IKE 339 / KE 680-1-2T

Problems with draining off water from defrosting

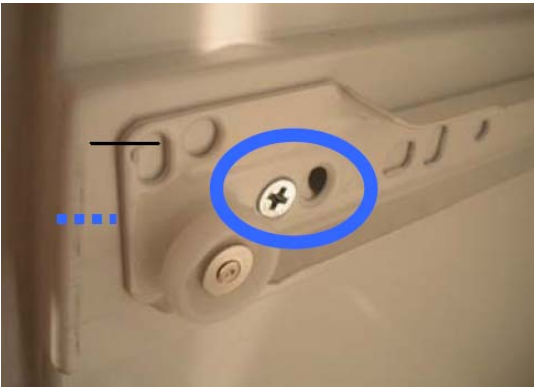
This error may occur when the guides of the refrigerator drawer have been mounted too far to the back. The drawer will then touch the bottom of the refrigerator section and prevent the condensation water from flowing into the discharge hole during the defrosting procedure in the refrigerator.

The guide rails only need to be fastened in a different position to solve this problem.

WRONG - guide rail in the first hole

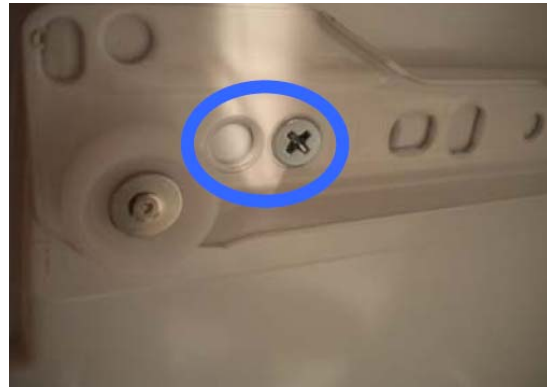
1. Check whether the guide rails are fastened in the first hole.
2. Remove the screws and fasten the guide rails again in the second hole (further to the outside in relation to the refrigerator section).

RIGHT - guide rail in the second hole
